May 31, 2023

Subject: PA-2023-026, 1218 Monte Diablo Ave., Pre-Application
1218 Monte Diablo Avenue, APN 033-171-060, -180

This letter summarizes initial comments from the City's Development Review Board and the Planning Division relating to the above referenced Preliminary Application "Pre-App" submittal from April 25, 2023. The comments from all reviewing departments are attached. Unless you request a second review to adjust the project based on staff's preliminary comments, the project can proceed with a neighborhood meeting and a Planning Commission Study Session, tentatively scheduled for June 29, 2023, and August 8, 2023 respectively.

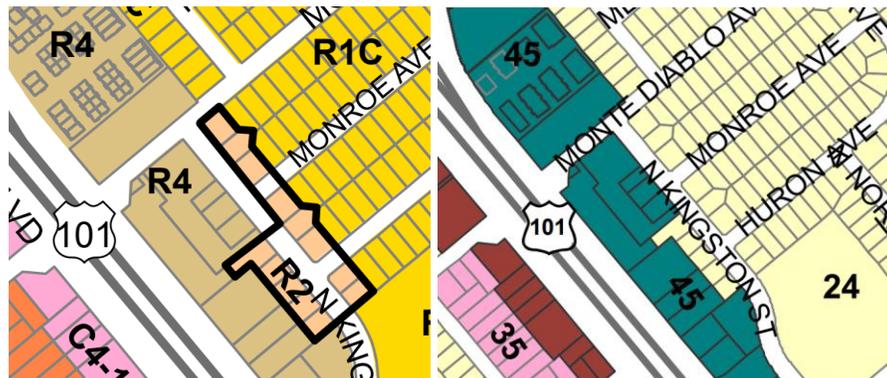
8. *Design Guideline A.* provides that a transition or step in height is necessary when height varies by more than one story between buildings. The difference in height between the proposed project and the low-density residences at 139 and 143 N. Kingston St. is three stories but does not provide an adequate transition to these lower height buildings. Staff recommends incorporating the townhome use and/or lowering the height of the building on each side of the 139 and 143 N. Kingston St. lots.

The Urban Design Element of the General Plan also provides that the scale of a neighborhood can be compromised as large-scale development with higher densities with larger, merged parcels are created. Staff recommends refining the building massing by providing greater step-backs, cut-outs, and changes in the roof line and height as the buildings approach lower density areas zoned R2 west of the site. Please see Urban Design Policy UD 2.2 and UD 2.7, as well as extracts of the Zoning Map (left) and Building Height Map (right) below delineating zoning and height boundaries in the site's vicinity.
